Access Compliance Report Public Rights-of-Way (Pedestrian Signals)

Main Street: **FOOTHILL_BLVD** Cross Street: **FOOTHILL_BLVD** Location: **SW**

ADA ID: **SGRK211011173506** Signal Type: **One Push Button-Non APS** Overall Compliance: **No** Severity Scores: **BTN 1: 25** **BTN 2: N/A** **No BTN: N/A**

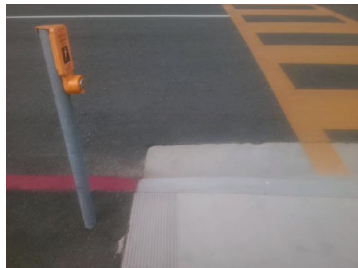
OC Std/PROW: **R404.2**

Possible Solutions: Remove and Replace Clear Space.
